SMYRNA MUNICIPAL PLANNING COMMISSION

April 3, 2025
5:00 p.m. meeting

AGENDA

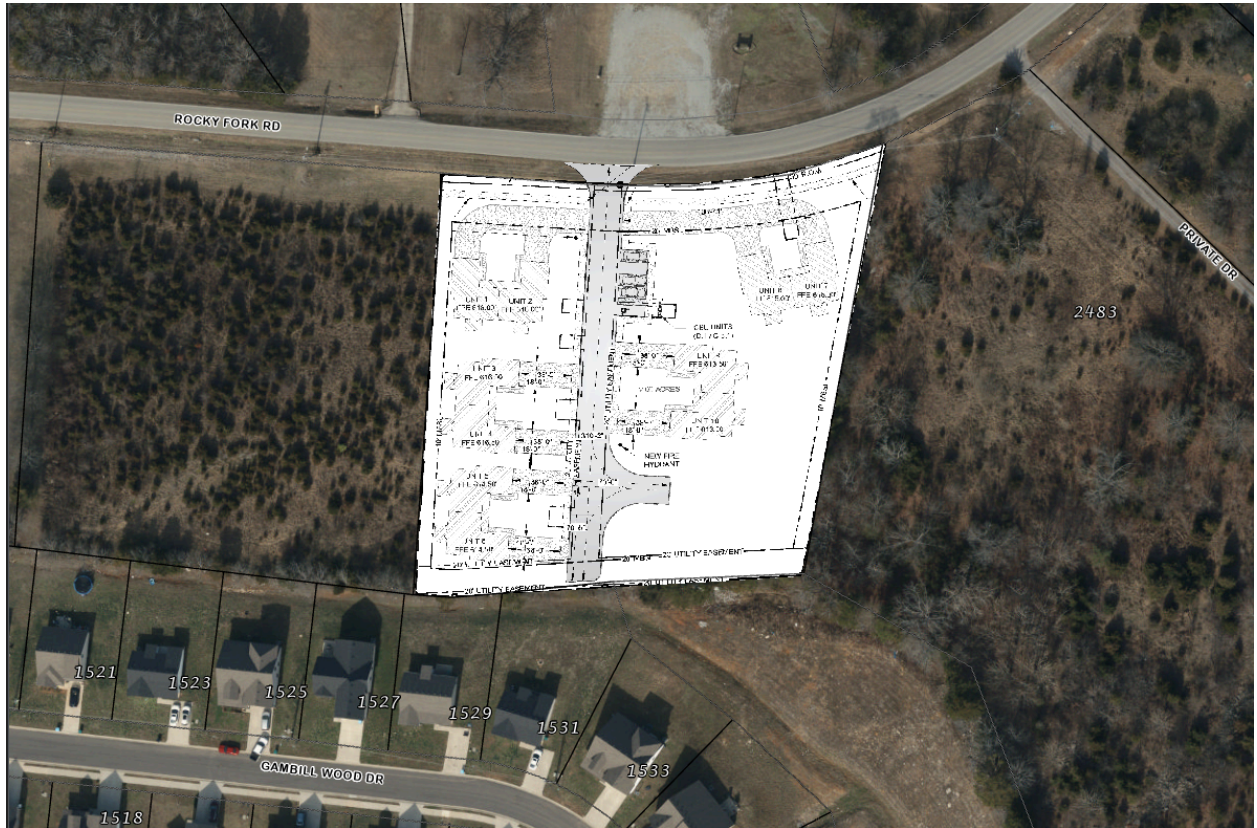
1. Submit and record the final plat prior to receiving building permits. Show right-of-way dedication and utility easements on the plat. Landscaping cannot be placed in the right-of-way.

2. Utility construction plans are under review.
3. Provide documentation where the developer has permission from the adjacent property owner to extend the sewer through the easement.

5. Show the driveway dimensions for Units 1, 2, 7 & 8. Adequate parking of four spaces per unit must be provided within the driveway without blocking access to the adjoining house.

6. The proposed landscaping plans do not meet the requirements of the Enon Springs Overlay. Please resubmit revised landscaping plans with the resubmittal, as no plans were included with the last submittal package.

7. Show the total square footage of landscaping provided.
8. Show how runoff from impervious surfaces will be directed to the detention areas.
9. Submit the profile sheet for sewer line D.

10. The ADA parking space must meet van accessible width requirements.
11. Update the parking detail to meet, at least, the Town of Smyrna minimum dimension requirements on all applicable pages.
